TROJAN-UNIT 1  
 9009260123 900918  
 PDR ADDCK 05000344  
 P DDC

TABLE 3.6-1

CONTAINMENT ISOLATION VALVES

I hereby certify that copies of License Change Application 203 to the Operating License for Trojan Nuclear Plant, dated September 18, 1990, have been served on the following by hand delivery or by deposit in the United States mail, first class, this 18th day of September 1990:

3/4 6-17

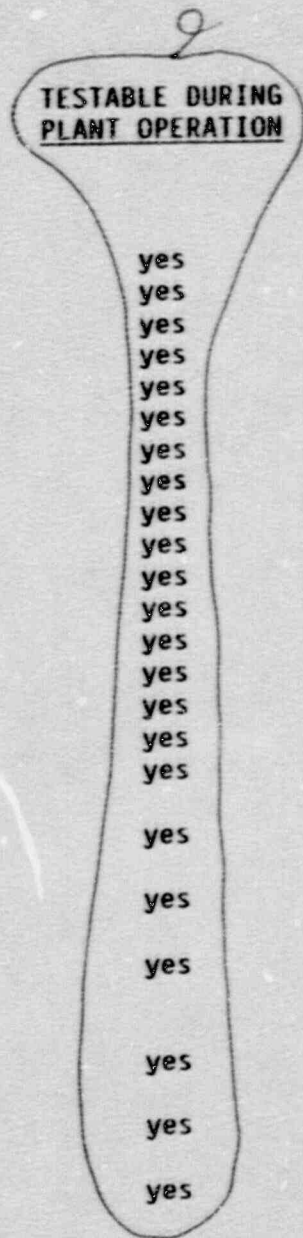
VALVE NUMBER	FUNCTION	TESTABLE DURING PLANT OPERATION	ISOLATION TIME (seconds)
<b>A. Containment Isolation</b>			
MO 5658*	PRZ steam sample - Inside	yes	10
CV 5659*	PRZ steam sample - Outside	yes	10
MO 5656*	PRZ water sample - Inside	yes	10
CV 5657*	PRZ water sample - Outside	yes	10
MO 5653*	Reactor Coolant Loop Sample - Inside	yes	10
MO 5654*	Reactor Coolant Loop Sample - Inside	yes	10
CV 5655*	Reactor Coolant Loop Sample - Outside	yes	10
MO 5651A*	Accumulator "A" Sample - Inside	yes	10
MO 5651B*	Accumulator "B" Sample - Inside	yes	10
MO 5651C*	Accumulator "C" Sample - Inside	yes	10
MO 5651D*	Accumulator "D" Sample - Inside	yes	10
CV 5652*	Accumulators' Sample - Outside	yes	10
CV 2811#	S. G. "A" Sample - Outside	yes	N.A.
CV 2880#	S. G. "B" Sample - Outside	yes	N.A.
CV 2814#	S. G. "C" Sample - Outside	yes	N.A.
CV 2809#	S. G. "D" Sample - Outside	yes	N.A.
MO 6716#	S. G. "A" blowdown - Outside	yes	N.A.
MO <del>2808#</del> 2810

MO 6717#	S. G. "B" blowdown - Outside	yes	N.A.
MO <del>2810#</del> 2813			
MO 6718#	S. G. "C" blowdown - Outside	yes	N.A.
MO 2812#			
MO 6719#	S. G. "D" blowdown - Outside	yes	N.A.
MO <del>2813#</del> 2808			
MO 5674	Containment atmosphere sample supply - inside	yes	10
MO 5675	Containment atmosphere sample supply - outside	yes	10
MO 5672	Containment atmosphere sample return - inside	yes	10

3/4 6-18

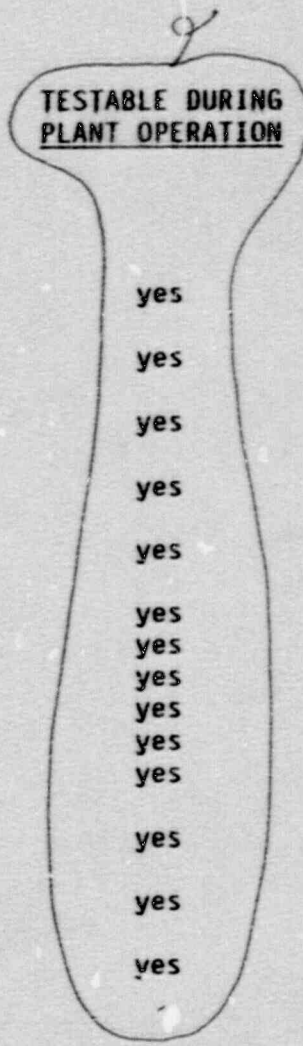
VALVE NUMBER	FUNCTION	TESTABLE DURING PLANT OPERATION	ISOLATION TIME (seconds)
A. Containment Isolation			
MO 5676	Containment atmosphere sample return - outside	yes	10
MO 5671	Containment atmosphere sample <del>supply</del> - outside	yes	10
MO 5673	Containment atmosphere sample <del>return</del> - inside	yes	10
MO 5663	Containment atmosphere sample <del>supply</del> - outside	yes	10
CV 8026	Pressurizer relief tank gas analyzer - inside	yes	10
CV 8025	Pressurizer relief tank gas analyzer - outside	yes	10
MO 5660	RCDT gas analyzer - inside	yes	10
CV 5661	RCDT gas analyzer - outside	yes	10
CV 4000	RCDT N <sub>2</sub> supply - outside	yes	10
MO 4005	RCDT discharge - inside	yes	10
CV 4006	RCDT discharge - outside	yes	10
CV 8028	Pressurizer relief tank makeup - outside	yes	10
MO 5677	Containment atmosphere sample supply - outside	yes	10
MO 5678	Containment atmosphere sample return - outside	yes	10

3/4 6-21

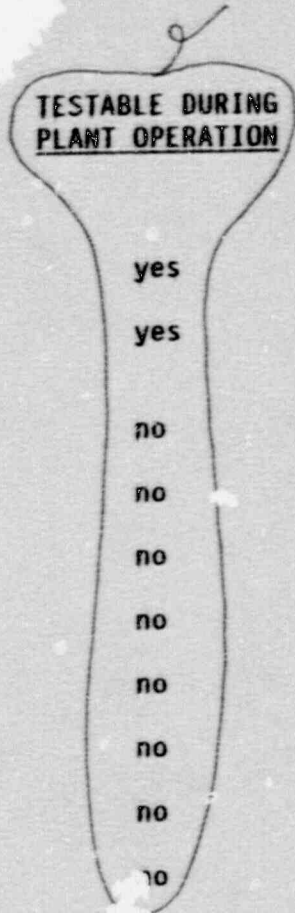
VALVE NUMBER	FUNCTION	TESTABLE DURING PLANT OPERATION	ISOLATION TIME (seconds)
C. Steamline Isolation			
CV 2277#- 2280#	Main Steam Isolation Bypass Line	yes	N.A.
CV 2294#- 2297#	Main Steam Line Steam Trap	yes	N.A.
CV 2210#	Main Steam Power Operated Reliefs (no isolation signal)	no	N.A.
CV 2230#	Main Steam Power Operated Reliefs (no isolation signal)	no	N.A.
CV 2250#	Main Steam Power Operated Reliefs (no isolation signal)	no	N.A.
CV 2270#	Main Steam Power Operated Reliefs (no isolation signal)	no	N.A.
<del>CV 1451</del> <del>NO 2210#</del>	Main Steam Supply to Auxiliary FW Pump Turbine Driver	no	N.A.
<del>CV 1452</del> <del>NO 2220#</del>	Main Steam Supply to Auxiliary FW Pump Turbine Driver	no	N.A.
<del>CV 1453</del> <del>NO 2230#</del>	Main Steam Supply to Auxiliary FW Pump Turbine Driver	no	N.A.
<del>CV 1454</del> <del>NO 2240#</del>	Main Steam Supply to Auxiliary FW Pump Turbine Driver	no	N.A.
